2004 - 2009 Cadillac XLR and XLR-V: Service Bulletin: XLR Roof Does Not Latch At Rear Corners In Stowed Position

#PIC4547A: XLR Roof Does Not Latch At Rear Corners In Stowed Position - keywords latch loose mid open potentiometer retract stow trunk - (Oct 23, 2008)

Models: 2004 - 2009 Cadillac XLR and V-Series

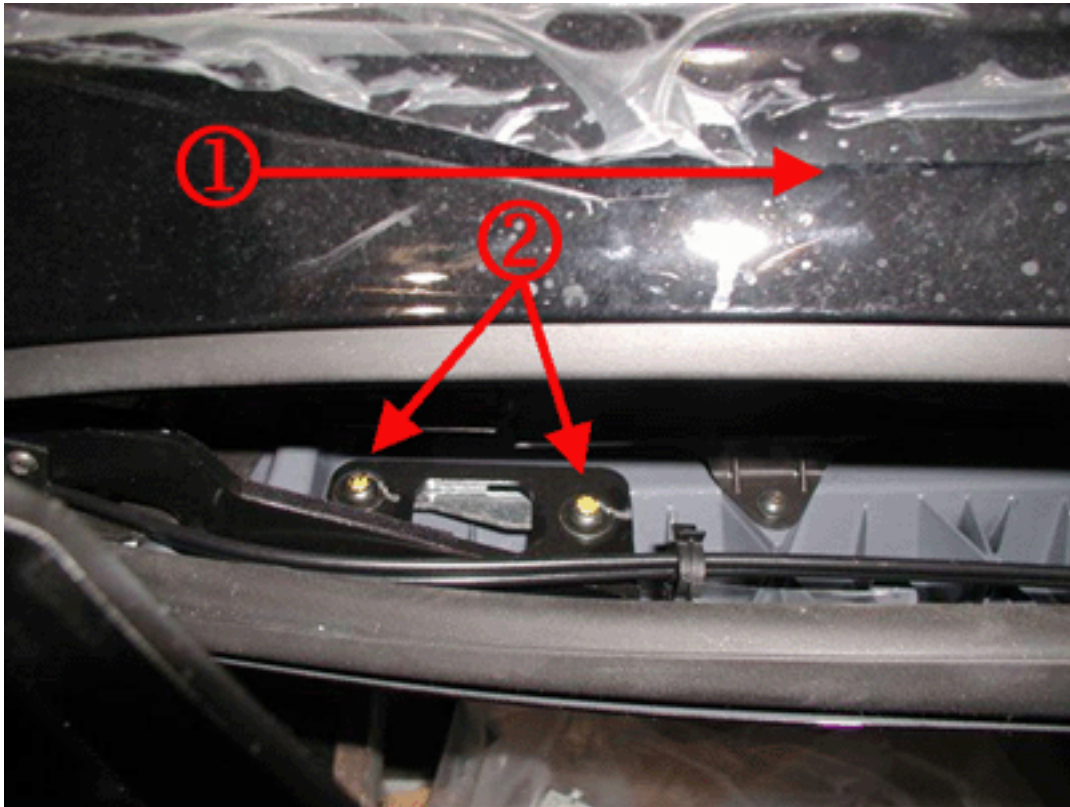
Some customers may comment of a mark in the paint on the roof panel. This mark may be on the drivers or passengers side of the roof and typically the size of a pencil eraser. Further inspection of the retractable roof may indicate when the roof is stowed, the rear corners of the roof are not secured in trunk area. This may be the result of a misadjusted roof panel.

1. Lower roof into trunk as far as it will go. Stop when trunk starts to close. Check to see if the rear roof latches engage the lower support.
2. Scribe the current position of the rear roof panel pivot bracket bolts. These marks may be needed if the panel moves more than needed. The position should only change about .5 mm (one half mm).

3. Loosen both of the rear roof pivot brackets to rear roof panel fasteners one turn (both driver and passenger sides). These only need to be loose enough to allow the bracket to slide under the bolt shoulder. Do not allow the shims (if present) to become mis-positioned.

4. Manually lower the panel so the rear latches engage and latch. Lightly bump/thump the rear corners of the roof panel above the latches using your open palm.

5. Re-tighten the previously loosened fasteners to the specifications listed in S.I (Doc I.D. = 1739799)
6. Cycle the roof and ensure that it latches properly in both the up position and down position with out assistance. If it does not latch in the up position the strikers can be adjusted.

(1) Front Of Vehicle

(2) Loosen One Turn
